MAINE DEPARTMENT OF HUMAN SERVICES
APPLICATION FOR PRIVATE SEWAGE DISPOSAL PERMIT

Town: Augusta Street, Road, etc.: Riverside Drive Rt. 201 Plumbing Permit No.: 8857EP Date of Plumbing Permit: 5-5-78

Name & type of establishment: Parker-Danner Co. 450 gpd Is lot Zoned? Yes No Type of Zoning: N/A Shoreland Resource Protection

Subject: Waiver to the Maine Plumbing Code, Part II,
Parker-Danner Company, Riverside Drive, Augusta

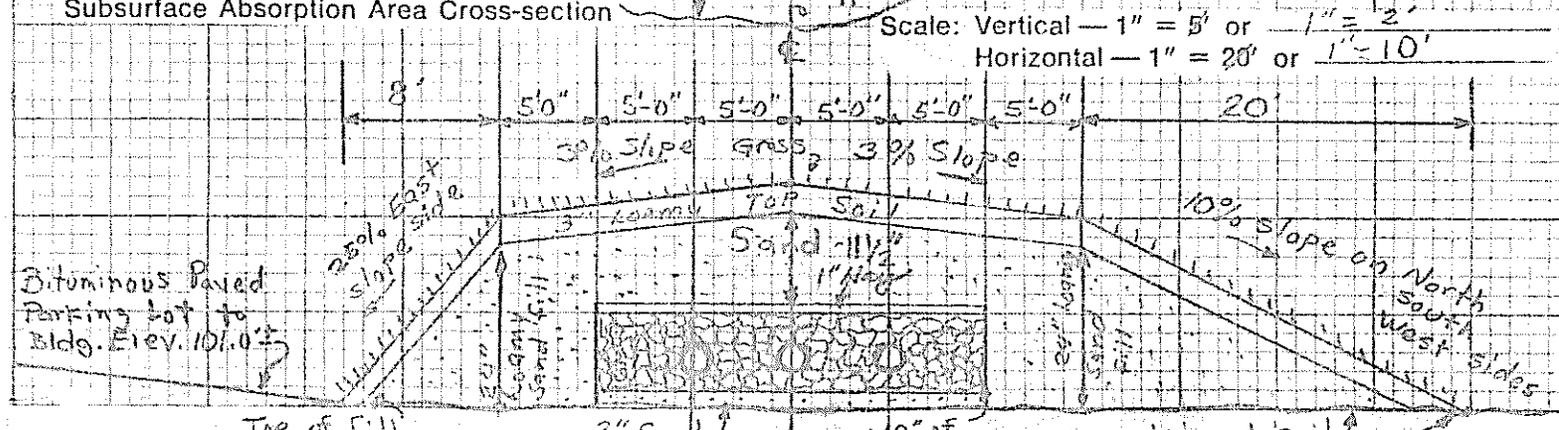
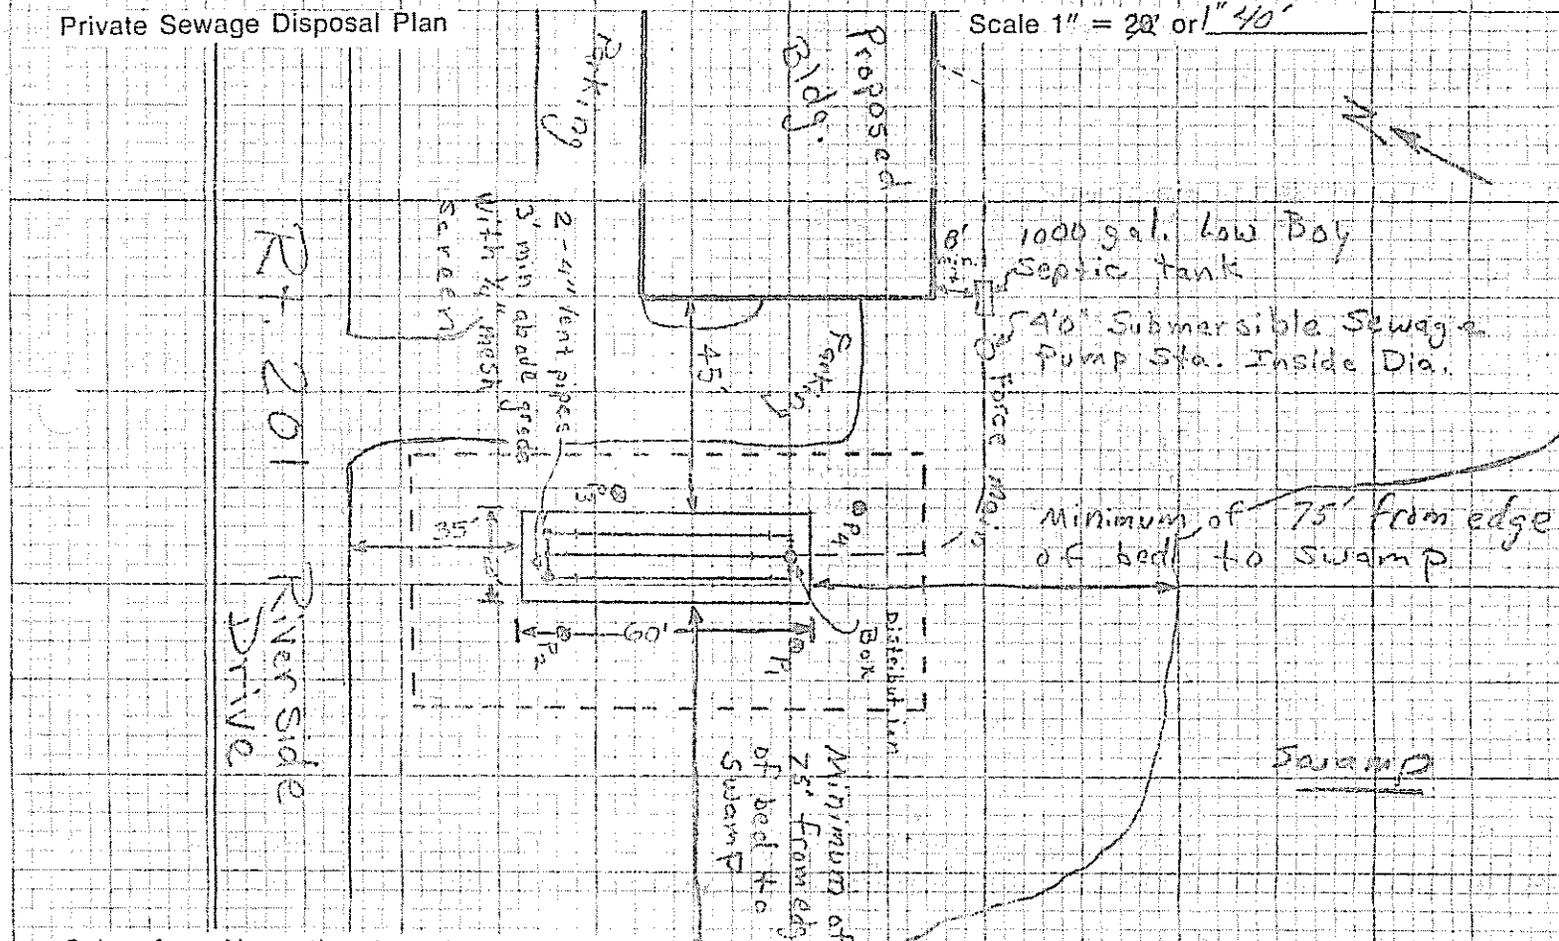
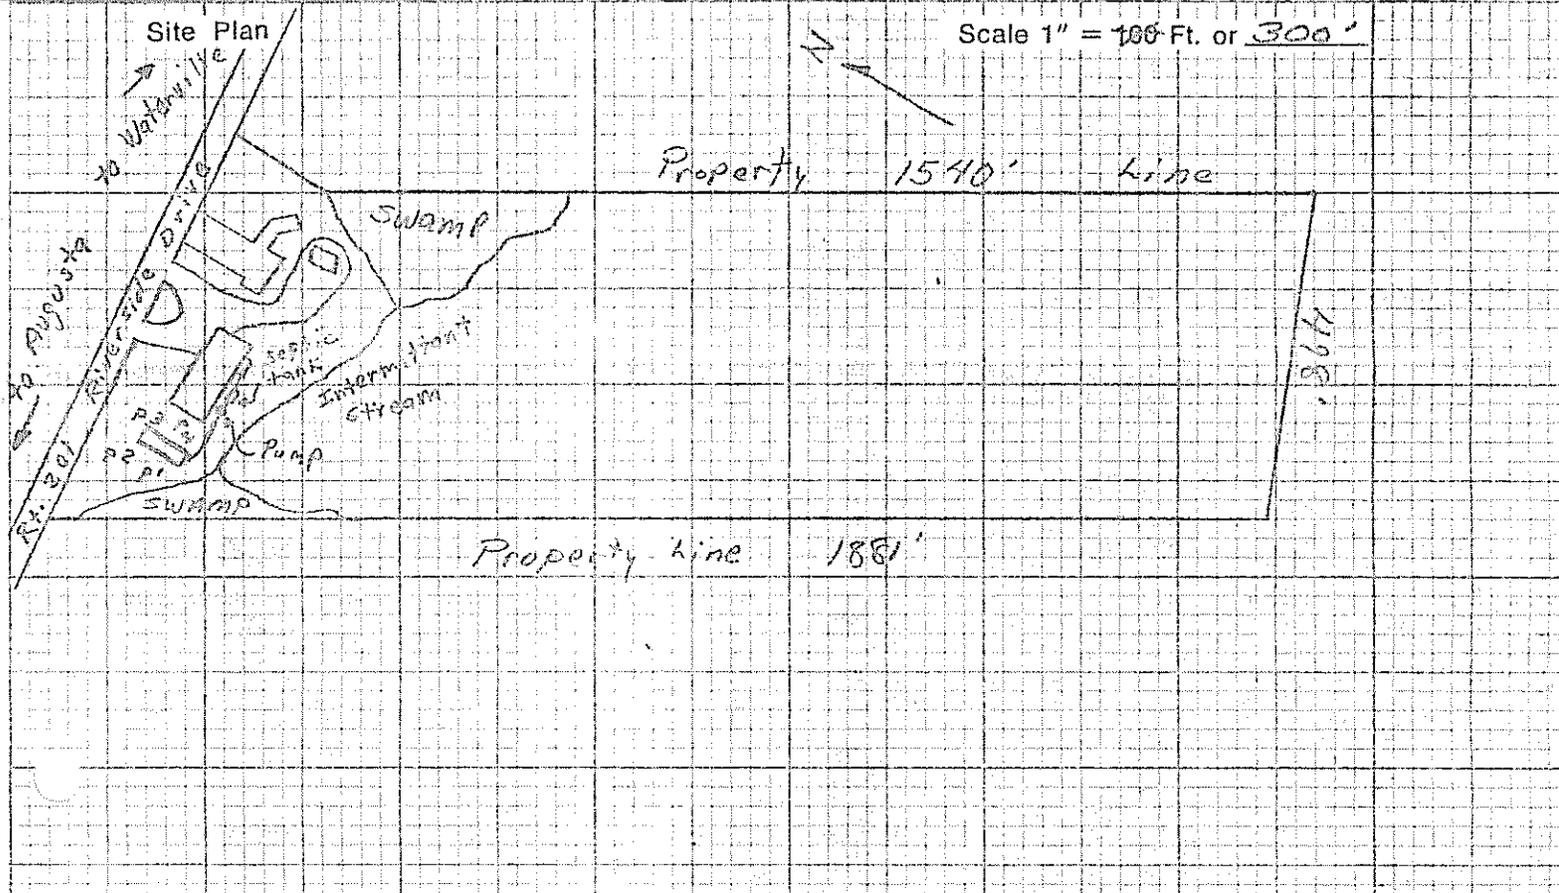
This will acknowledge receipt of a waiver request and a plan with soils information by David Rocque, Site Investigator, showing the replacement sewage disposal system for the subject project. It is not in compliance with the Maine Plumbing Code, Part II, because of 1) location of disposal system in madeland, and 2) setback from a swamp, the reasons for the waiver request.

After review, we are unable to grant our approval for the disposal system as designed, due to the extremely marginal site conditions. However, in consideration of the fact that this installation is a replacement of an existing facility, this office would be agreeable to the following:

1. The installation of a 1000 gallon septic tank to be followed by an 85 gallon dose lift station discharging to a raised 20'x60' disposal bed.
2. At least 24 inches of a sandy loam fill shall be applied on the upslope and downslope sides of the disposal bed. The fill shall be extended to the north, west, and south for 5 feet at 3 percent, then extended to the original ground at a 10 percent slope. Fill to the east shall be as indicated on the plan dated October 11, 1977.

3. Additional sandy loam fill shall be placed so that no part of the disposal bed is located less than 75 feet from the edge of the swamp land.
4. The use of water conserving plumbing fixtures within the building shall be required.

5. The building owners shall file a statement with the city of Augusta acknowledging the marginal nature of the site for sewage disposal, and accepting full responsibility for correcting any future problems with the disposal system.
